**Determining the least damaging practicable alternative for the proposed Pebble Project:
Potentially less damaging practicable alternatives are improperly dismissed in the DEIS**

A Report Prepared for Earthworks
by
Thomas G. Yocom¹
Senior Wetlands Regulatory Scientist
Huffman-Broadway Group, Inc.

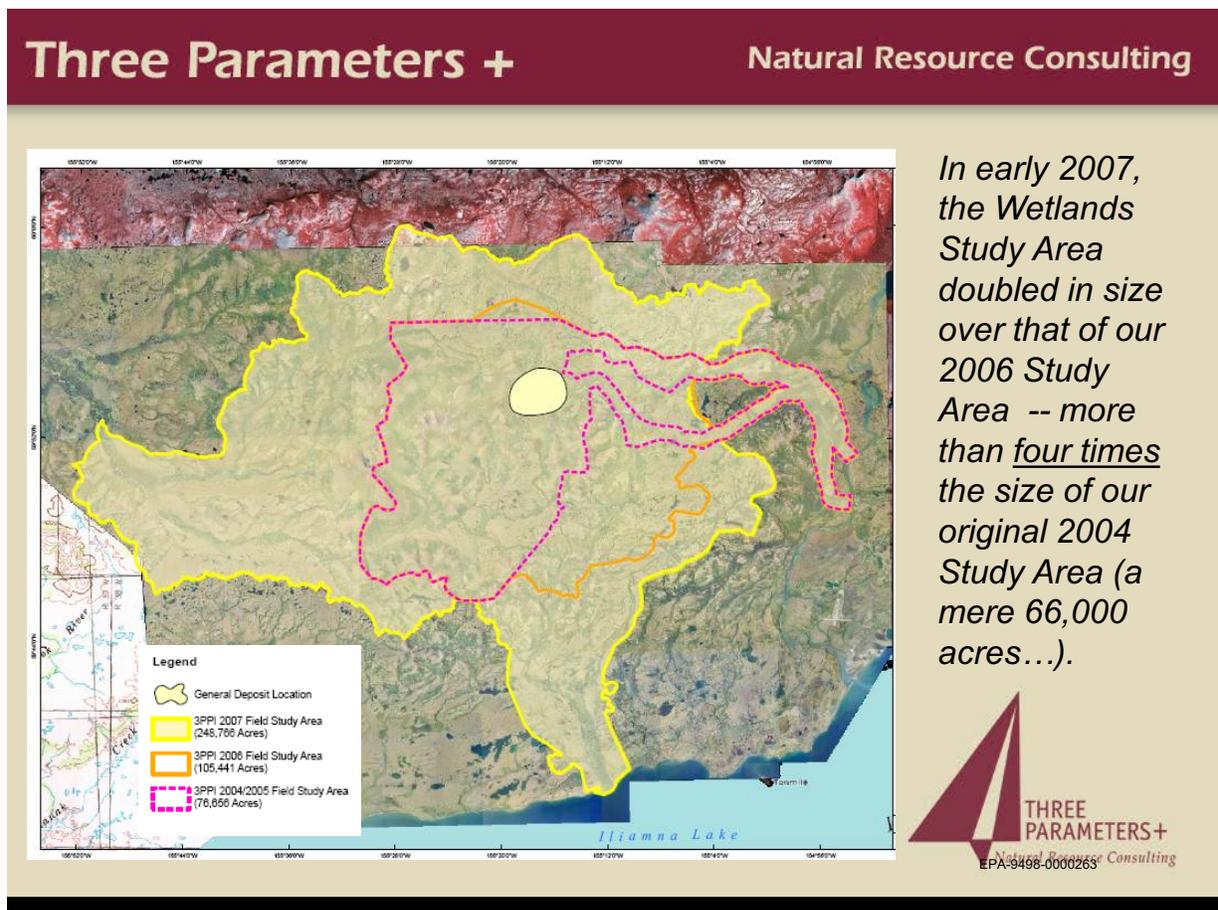
Table K2-1 gives acreage figures for each component of the overall project, but the wetland and aquatic impacts of each are not given, but should be.²⁵ The DEIS should describe why these project features cannot be resized, relocated, or reconfigured to reduce impacts to wetland and aquatic areas. The applicant has made numerous changes to its proposed project footprints over the past several years, as well as since submitting its permit application in December 2017. The applicant should clearly demonstrate that it cannot further reduce its impacts practicably.

In doing so, the DEIS should include expanded maps of wetland and aquatic areas that reflect the far more extensive delineations completed by the applicant beginning in 2004. The mapping included in the Corps' Preliminary Jurisdictional Determination (PJD) uses a "study boundary" that is far smaller than the areas that were mapped by PLP in its Environmental Baseline Documents (see figure below from a presentation made by one of PLP's consultants in 2007: <https://foiaonline.gov/foiaonline/api/request/downloadFile/EPA-9498-0000258-EPA-9498-0000296.pdf/2146f53e-4838-4b9e-97c0-b35fe6c7a408>).
